Ref. Docket No. 40-6622, Source Material License No. SUA-442  
Revision to the Shirley Basin Mine Application for Alternate Concentration Limits

## REPLACEMENT PAGES

## **4.2 PROPOSED IMPLEMENTATION MEASURES**

<b>PATHFINDER</b> PATHFINDER MINES CORPORATION SHIRLEY BASIN, WYOMING T28N, R78W		
FIGURE 42-1 PLANNED ACL SAMPLE LOCATIONS		
DRAWN BY TGM	DATE: 10-2002	SCALE 1"=800'
		SAMPFIG DWG
REVIS NO	HYDRO-ENGINEERING LLC

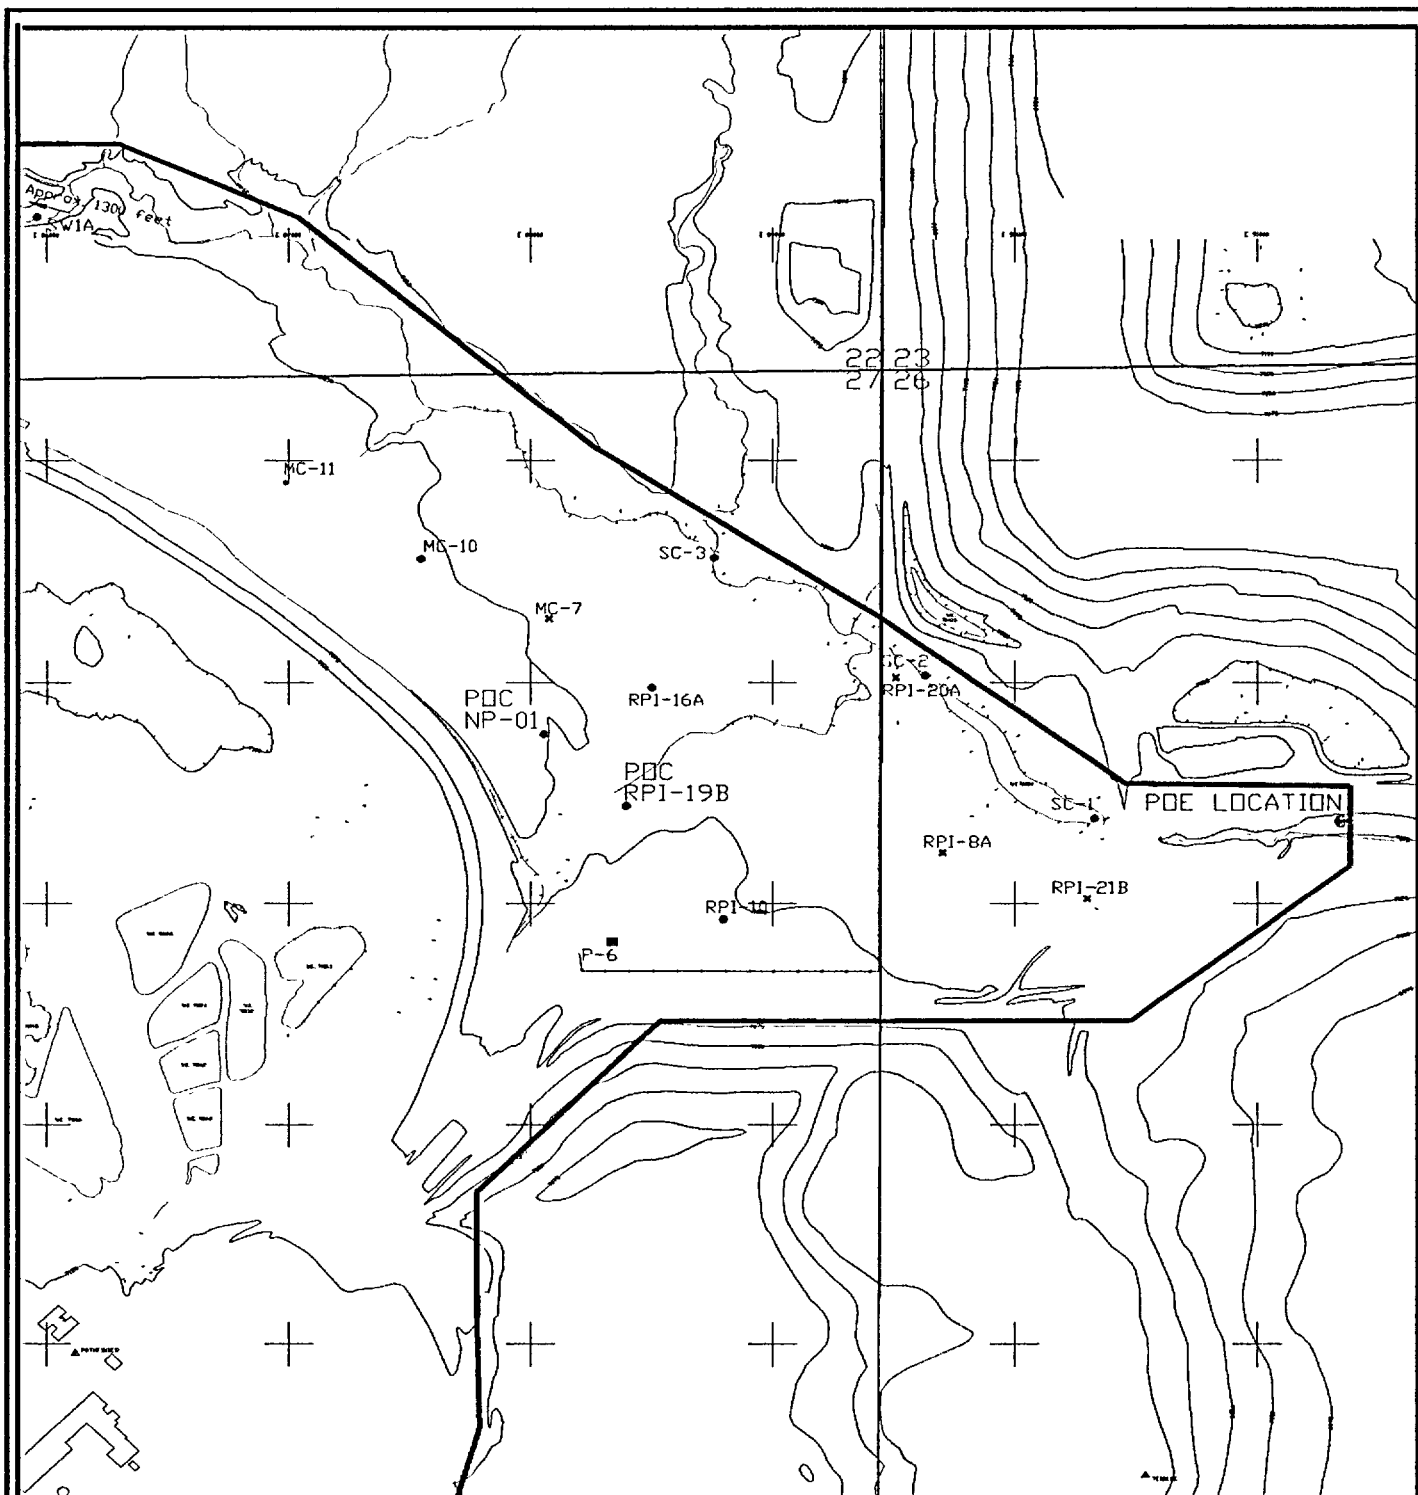
Quarterly monitoring will be done for the two POC wells (NP01 and RPI-19B) and wells MC-7, MC-10, MC-11, P-6, RPI-8A, RPI-10, RPI-16A, RPI-20A, and RPI-21B, to span the area of measurable ground-water impacts along Spring Creek. Quarterly samples will be taken from five locations along Spring Creek including the POE and locations SC-1, SC-2, SC-3, and SW1A (see Figure 4.2-1). The SW1A site is located in Spring Creek upstream of the tailings. Both surface and ground water samples will be analyzed for uranium, selenium, TDS, chloride, arsenic, barium, beryllium, cadmium, chromium, lead, molybdenum, nickel, nitrate and sulfate concentrations, and thorium-230, radium-226 + radium-288 and gross alpha activities. Field parameters of field pH, conductivity and water levels in wells will also be taken during sampling. The first sampling will occur within two months of cessation of the CAP operation.

The purposes of this monitoring are to assure that PMC remains in compliance with the ground water standards in the license, to adequately monitor ground water plume movement over time and distance, and to assure that ground water contamination does not present an unacceptable risk to human health or the environment. If a ground water standard at a point of compliance is exceeded, the licensee shall notify the NRC within 30 days and shall increase the sampling frequency to monthly, until it is
